Amendment Under 37 C.F.R. § 1.116
USSN 10/038,586
Attorney Docket Q67753

For: WEATHER STRIP WITH A PRESSURE SENSITIVE SAFETY SWITCH FOR AN
OPENING WITH WHICH A MOTOR-DRIVEN CLOSURE ELEMENT IS
ASSOCIATED

SUBMISSION OF CORRECTED DRAWINGS

Fig. 1
Prior Art

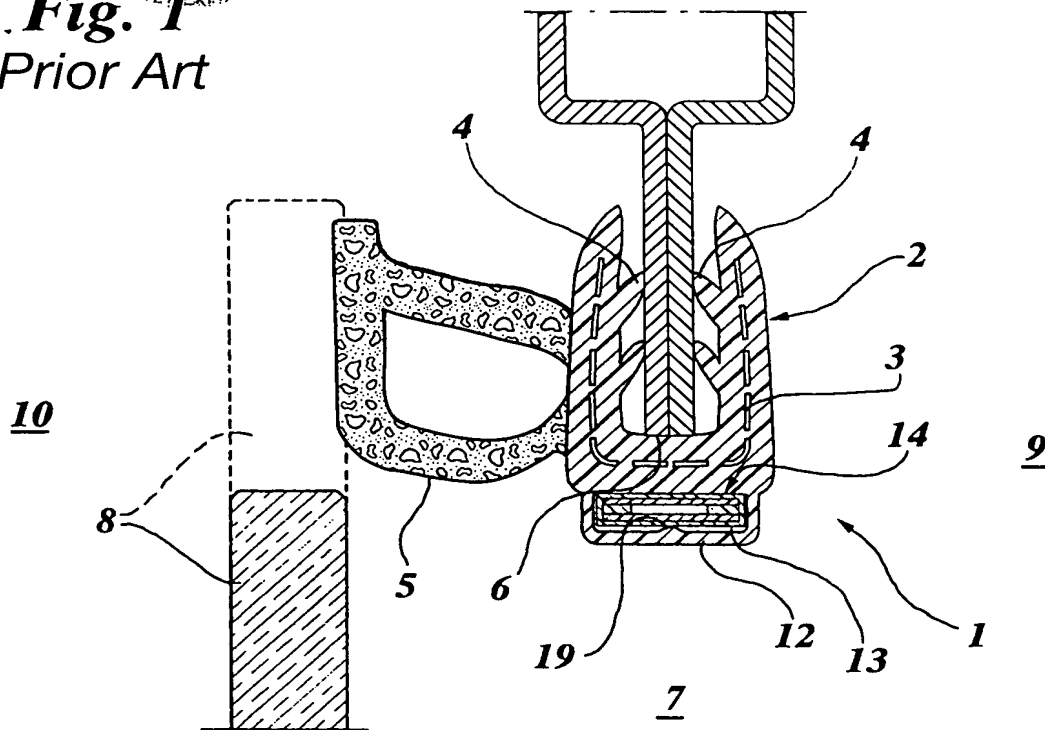
Three sheets of formal drawings containing figures 1-5 inclusive are submitted herewith. Figures 1 and 2 have been amended to identify these figures as prior art and figure 5 has been amended to include the various reference numeral changes. These changes to the drawings were previously approved.
